**SUBDIVISION REVIEW SHEET****CASE NO.:** C8J-2015-0255**P.C. DATE:** May 9, 2017**SUBDIVISION NAME:** Easton Park Section 2B Preliminary Plan**AREA:** 174.34 acres**LOT(S):** 549**OWNER/APPLICANT:** Carma Easton , LLC  
(Logan Kimble)**AGENT:** Peleton Land Solutions  
(Paulo Misi)**ADDRESS OF SUBDIVISION:** 7901 Colton Bluff Springs Road**GRIDS:** K13**COUNTY:** Travis**WATERSHED:** Cottonmouth & N. Dry Creek**JURISDICTION:** Limited Purpose/ETJ**EXISTING ZONING:** PUD**MUD PLAN:** Pilot Knob MUD**PROPOSED LAND USE:** Residential

**SUBJECT:** Easton Park Section 2B  
Case No. C8J-2015-0255.SH

# EASTON PARK SECTION 2B SUBDIVISION PRELIMINARY PLAN

Contour Map

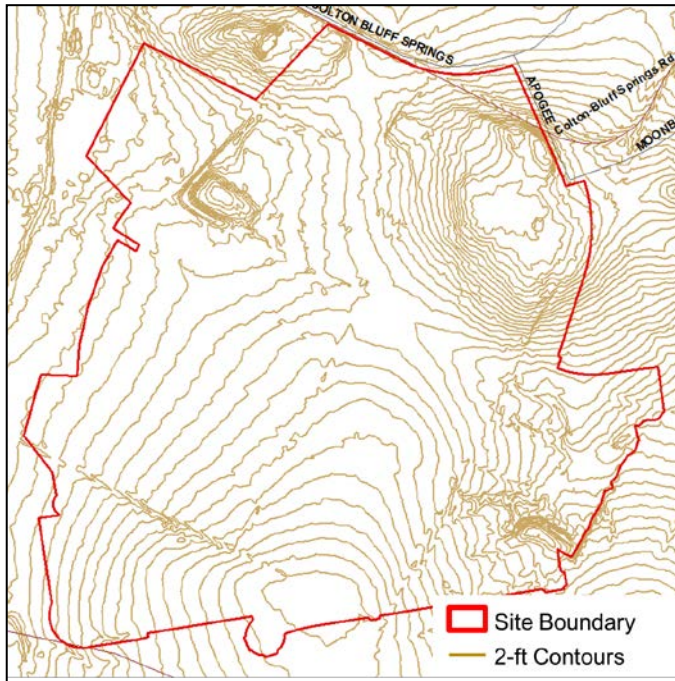
**Yes. Given the flat topography of the site, the requested variance is necessary to develop the site. In order to meet City of Austin design criteria for water quality, detention and storm sewer systems, the applicant must create artificial slopes for water to drain. In addition, the City requires a minimum slope in the bottom of water quality and detention ponds to be 2%. Applicant has requested a waiver from the Watershed Protection Department to reduce this slope to 1% in the bottom of proposed ponds in an effort to reduce the amount of grading on this site.**

**Fill is required to ensure that the water can flow to the ponds.**

**Yes. The flatness of the site makes it necessary to create slopes in order to achieve positive drainage.**

Staff recommends approval of the requested variance to allow fill 10 feet because the Findings of Fact for this variance have been met.
